REFERENCE:	Nova Bus Manuals
SECTION:	10 Transmission and control
RS N°:	MQR 7621-315
EFFECTIVE IN PROD.:	L702 (2012MA)

SUBJECT:	Ecolife transmission - Wiring harness for recording of turbine speed and output speed. ZF BULLETIN NO. 12_07.
JUSTIFICATION:	Due to wear at the plug connections of the wiring harnesses, sporadic contact discrepancies and entries in the error memory may occur.

Wiring Harness for Speed Recording of Turbine Speed (N_T) and Output Speed (N_Ab)

Components concerned:**Nova Bus note:**

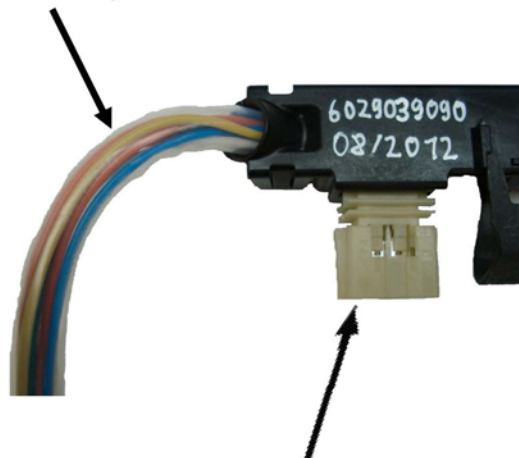
In the course of the technological further development, the plug connections of the wiring harnesses mentioned below were improved. New wiring harnesses were introduced by changes of the parts lists in the volume production for that.

Due to wear at the plug connections of the wiring harnesses, sporadic contact discrepancies and also entries in the error memory may occur.

The new wiring harnesses are clearly visible due to different individual lines in terms of color.

Due to improved plug connections, higher forces for plugging the wiring harnesses in are necessary!

In case of error, the wiring harnesses must be exchanged according to the following table:

Designation	NEW	OLD
	Material number	Material number
Wiring harness internal, turbine speed (N_T)	6029.039.090	6029.039.048
Wiring harness internal, turbine speed (N_T) with oil level sensor	6029.039.106	6029.039.061
Wiring harness, output speed (N_AB)	6029.039.091	6029.039.049

The wiring harness of the output speed (N_Ab) can be exchanged with small work efforts. If the oil pan is removed, an "insertion aid" (wire or something similar) is mounted to the wiring harness to be exchanged; with the help of this "insertion aid", the new wiring harness can then be inserted.

The transmission has not to be removed for the exchange of the wiring harness of the output speed (N_Ab).
